ADDENDUM NO. 2

UNIVERSITY OF SOUTH CAROLINA BEAUFORT CENTER FOR THE ARTS RENOVATION STATE PROJECT NO. H36-9518

June 15, 2017

H. Drawing E4.0 –

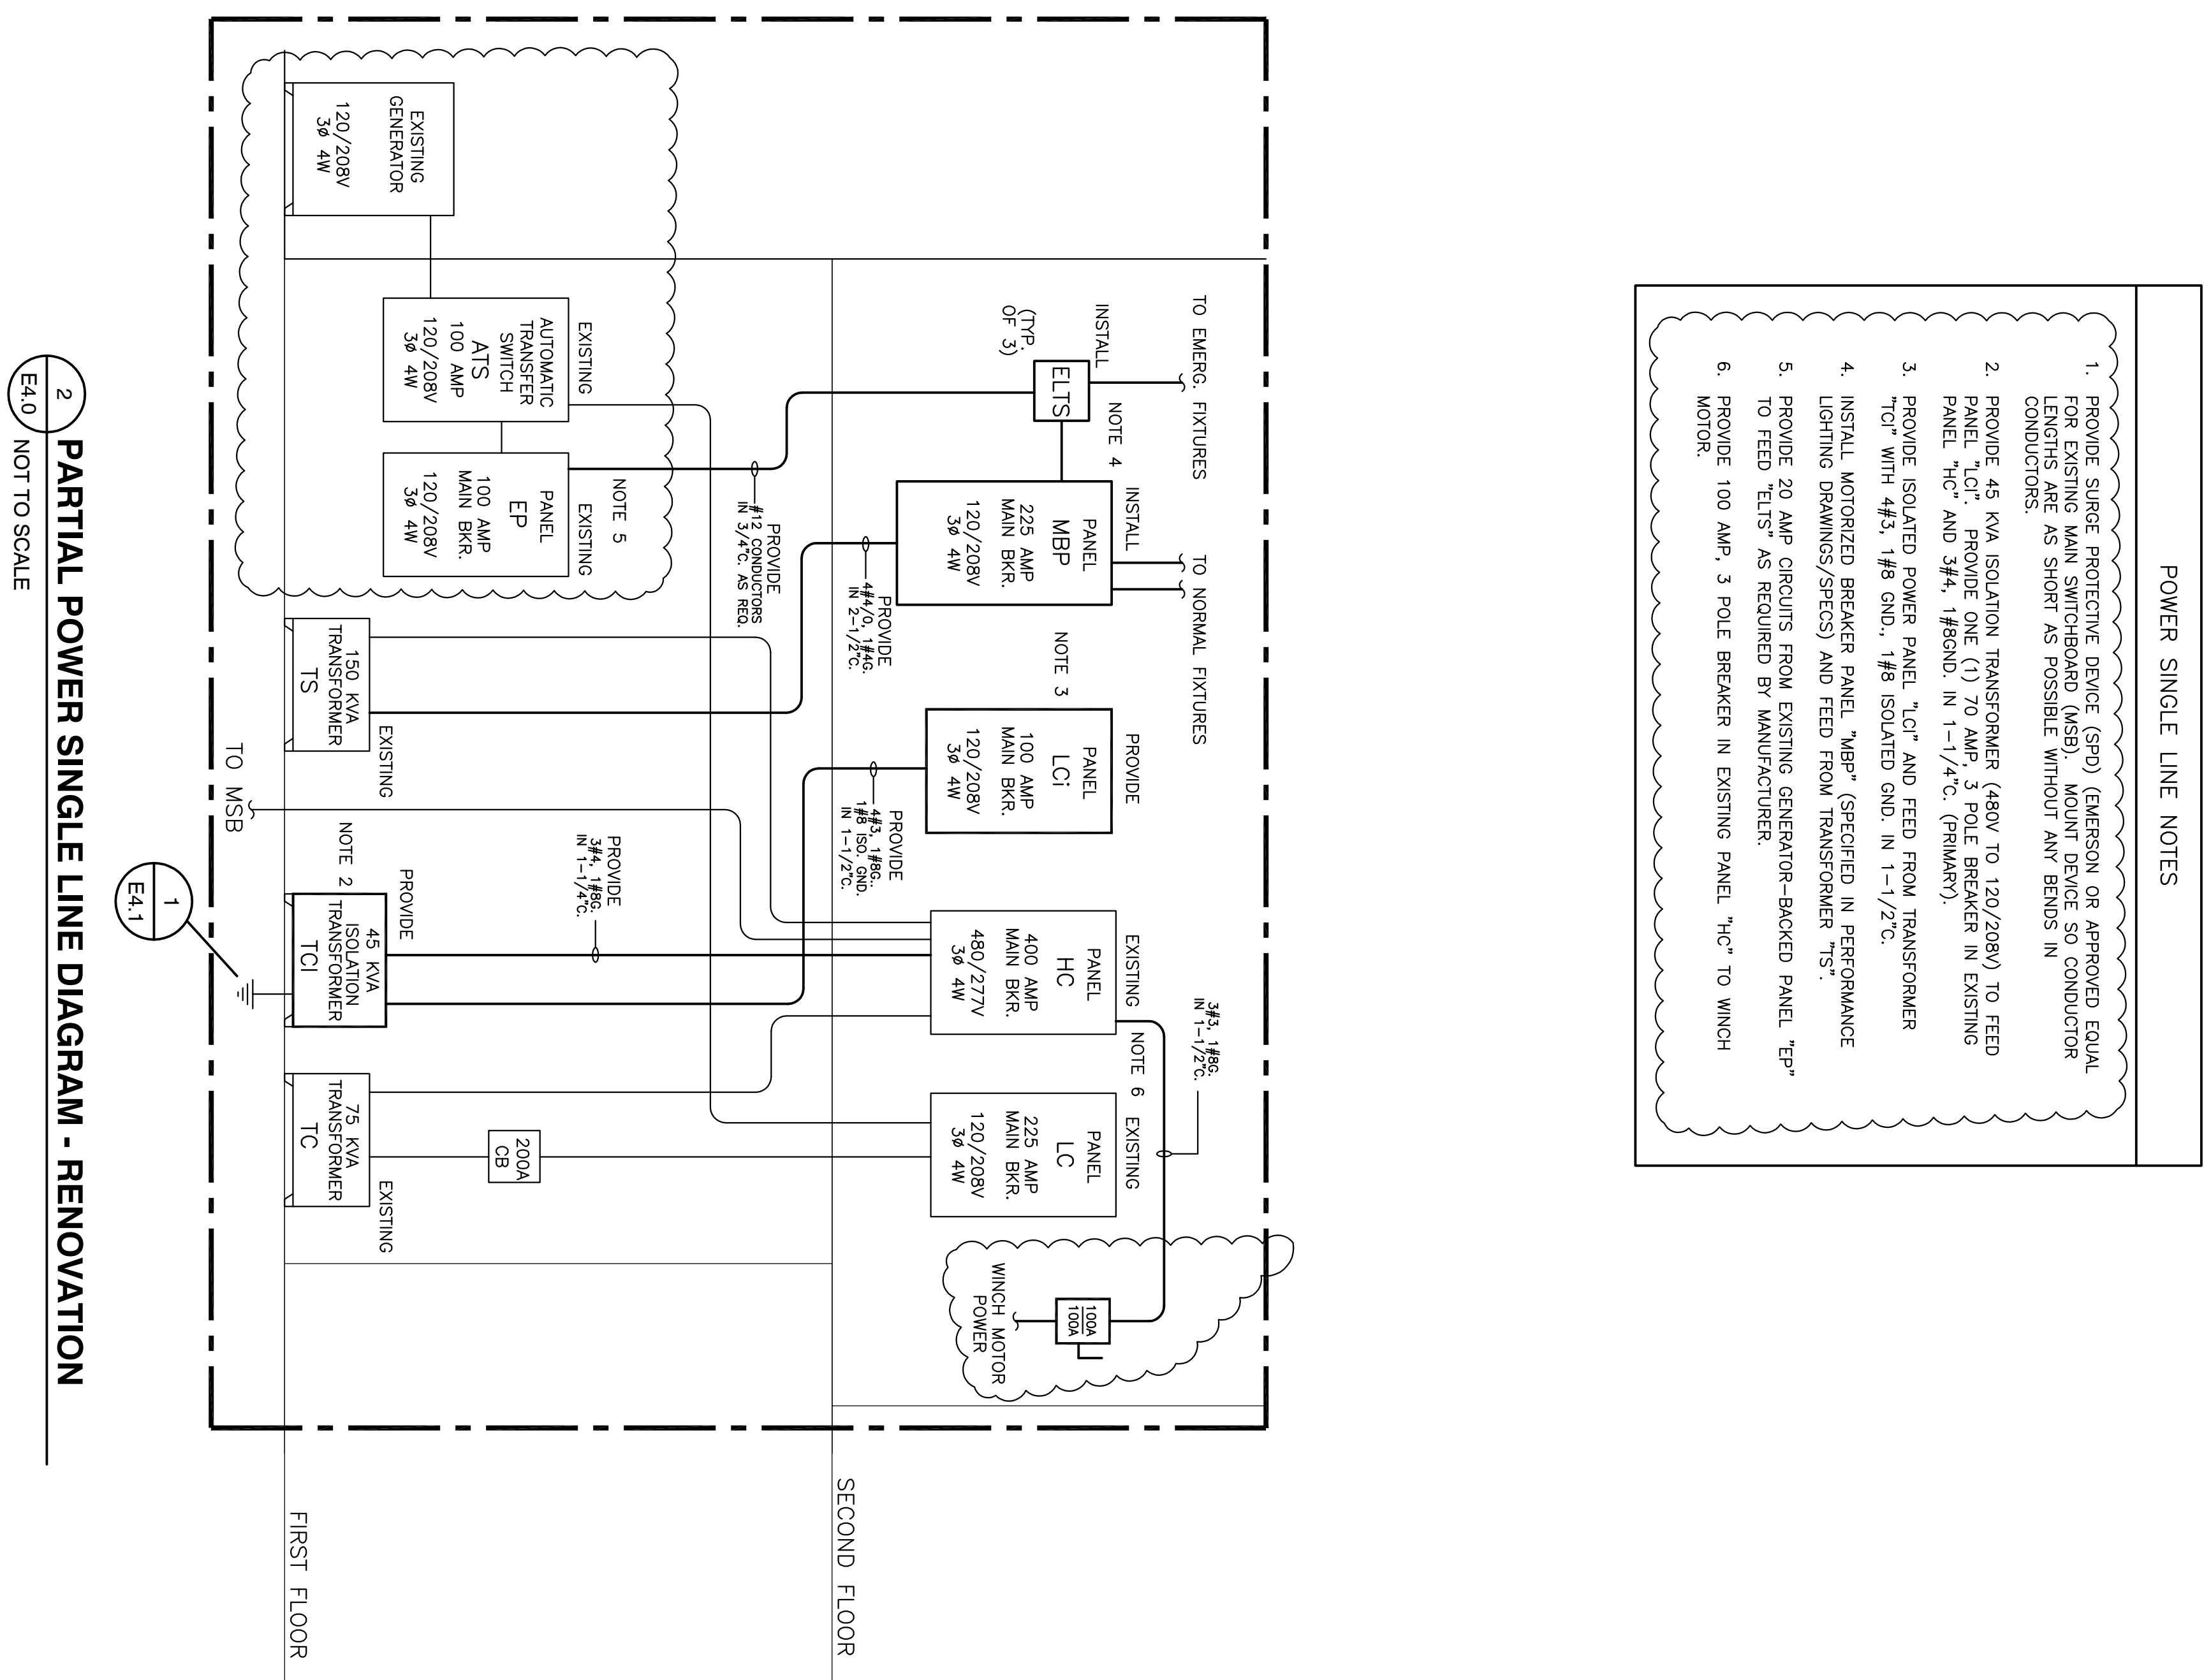
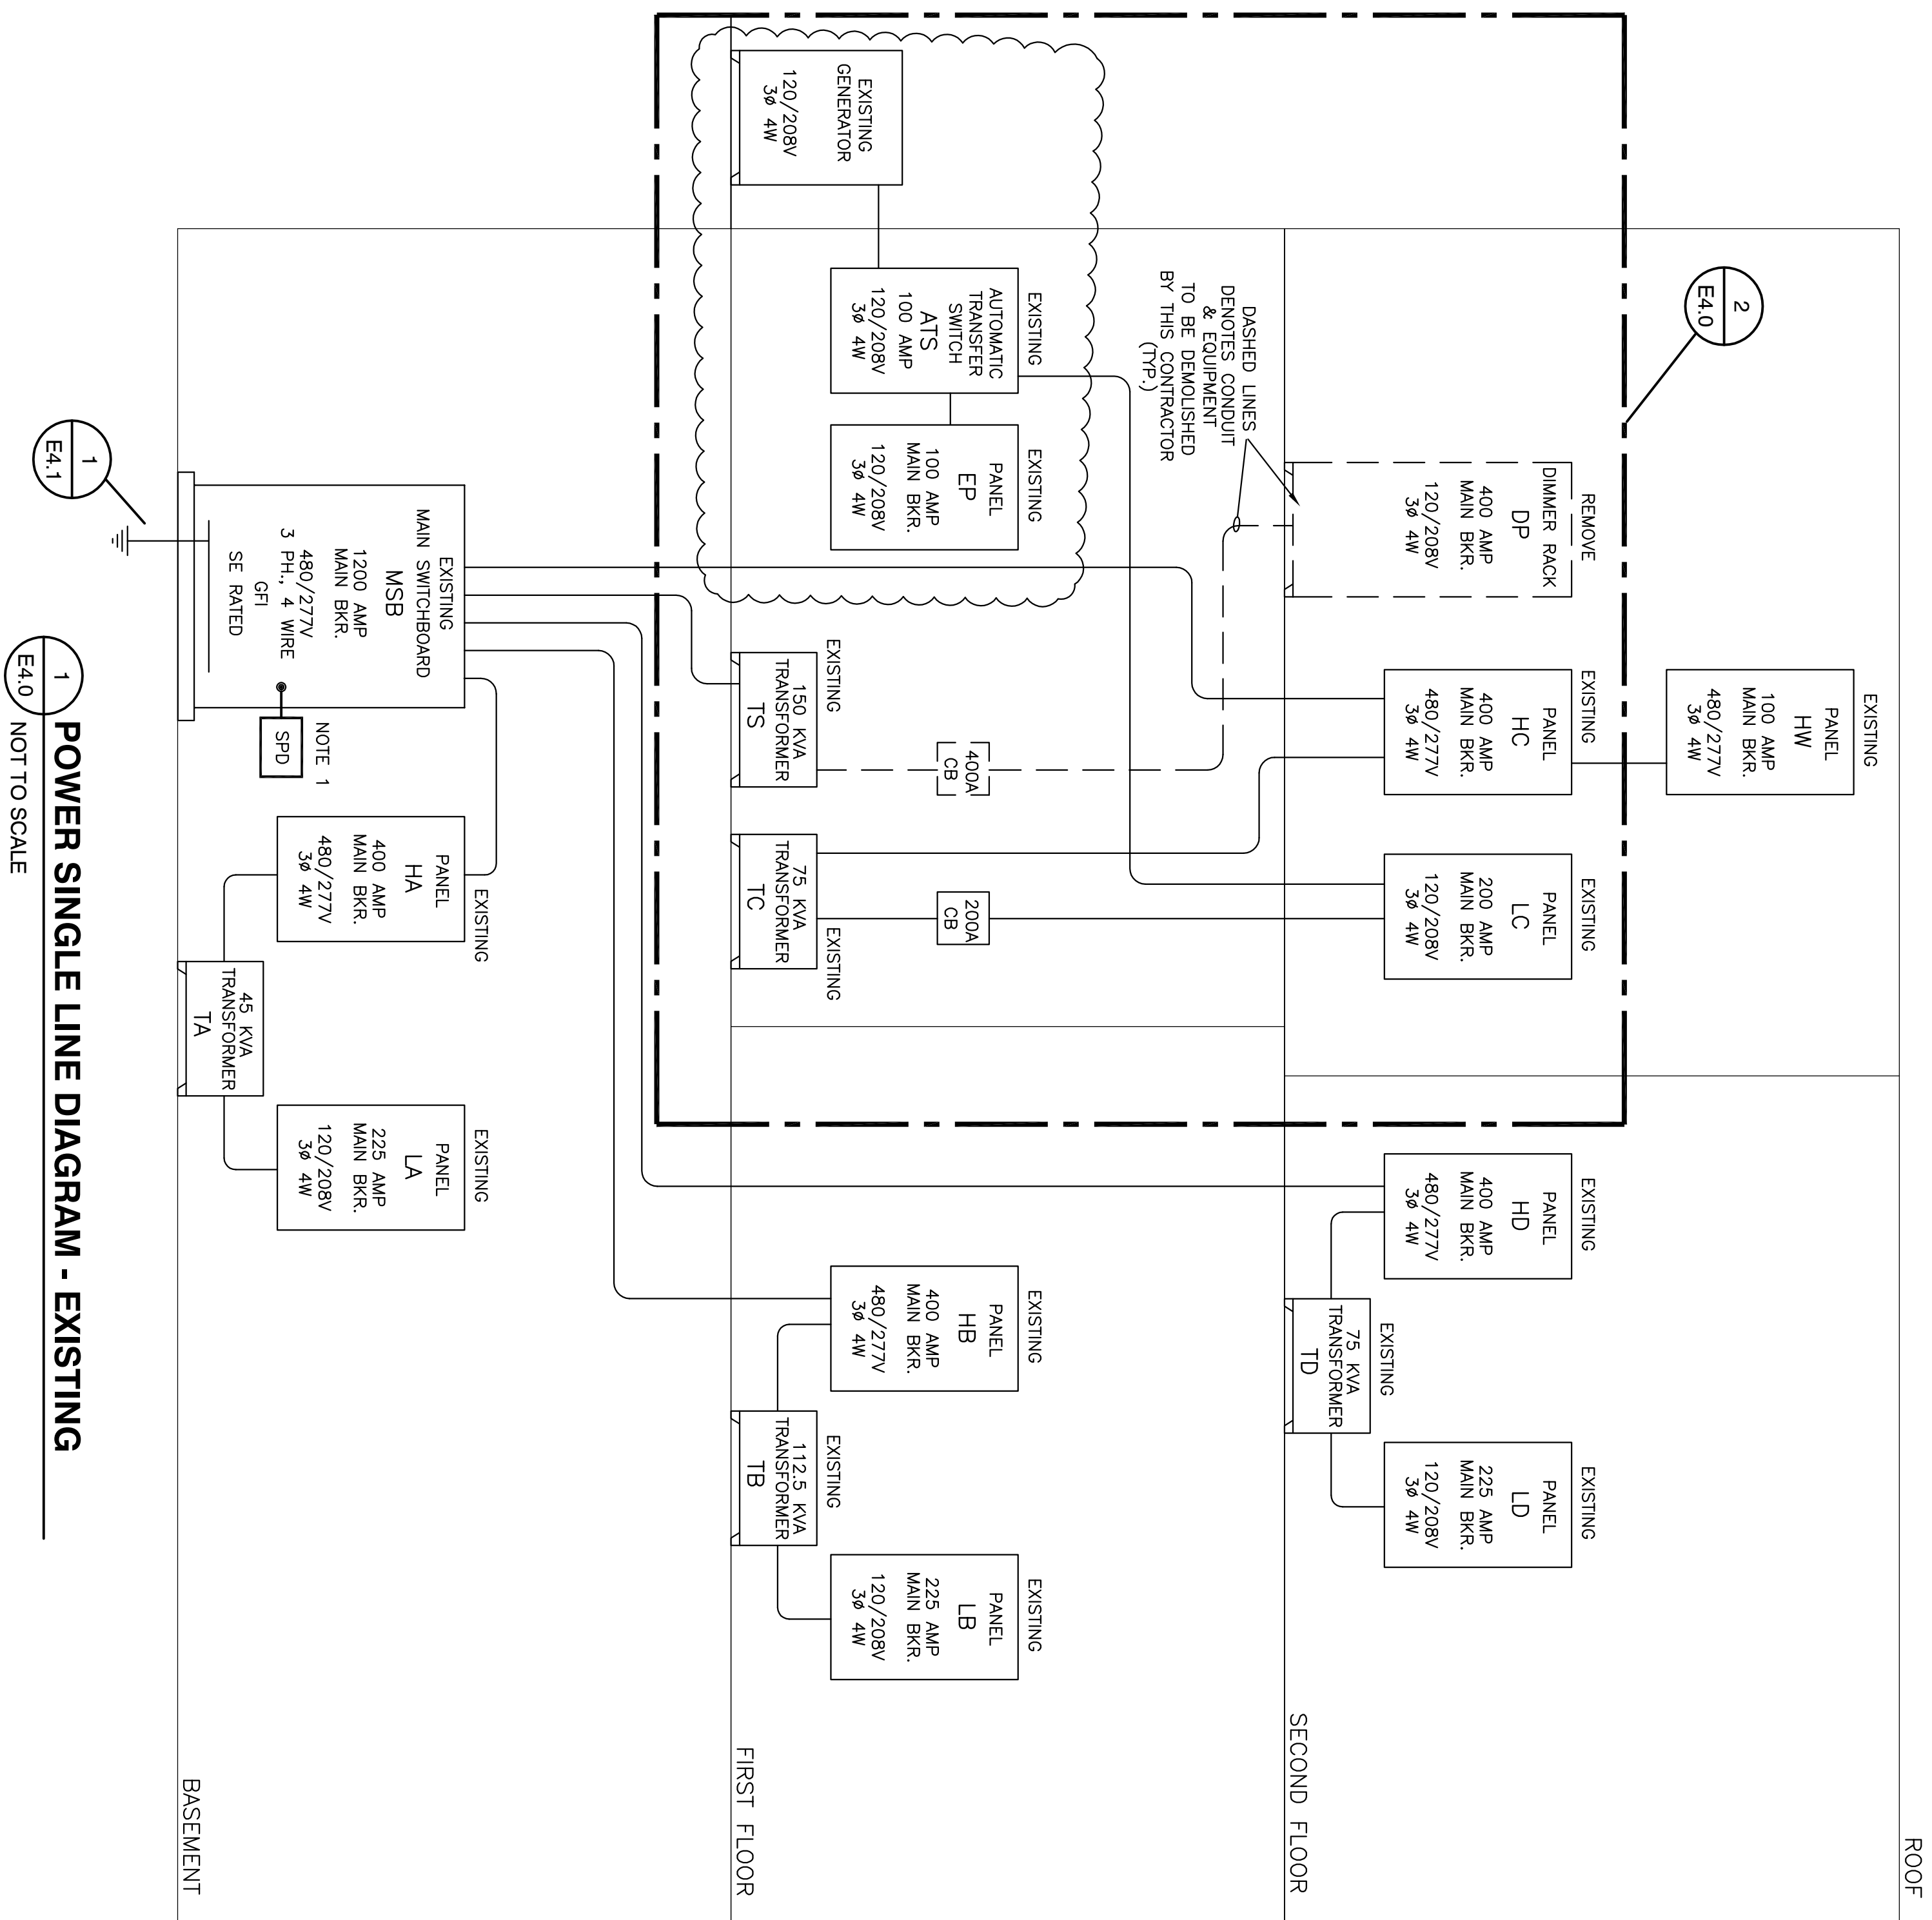
1. Replace entire drawing with attached drawing E4.0, Revision 1.

1. PROVIDE SURGE PROTECTIVE DEVICE (SPD) (EMERSON OR APPROVED EQUAL) FOR EXISTING MAIN SWITCHBOAR (ASB). MOUNT DEVICE SO CONDUCTOR LENGTHS ARE AS SHORT AS POSSIBLE WITHOUT ANY BENDS IN CONDUCTORS.
2. PROVIDE 45 KVA ISOLATION TRANSFORMER (480V TO 120/208V) TO FEED PANEL "1C1" TO PROVIDE ONE (1) 70 AMP, 3 POLE BREAKER IN EXISTING PANEL "1C1" AND #3/4, 1#8GND. IN 1-1/4" (PRIMARY).
3. PROVIDE EXISTING POWER PANEL "1C1" AND FEED FROM TRANSFORMER "1C1" WITH 4#3, 1#8 GND., 1#8 ISOLATED GND. IN 1-1/2".
4. INSTALL MOTORIZED BREAKER PANEL "MBP" (SPECIFIED IN PERFORMANCE LOADING DIAGRAMS/SPEC) AND FEED FROM TRANSFORMER "TS".
5. PROVIDE 20 AMP CIRCUITS FROM EXISTING GENERATOR-BACKED PANEL "EP" TO FEED "ELTS" AS REQUIRED BY MANUFACTURER.
6. PROVIDE 100 AMP, 3 POLE BREAKER IN EXISTING PANEL "1C1" TO WINCH MOTOR.
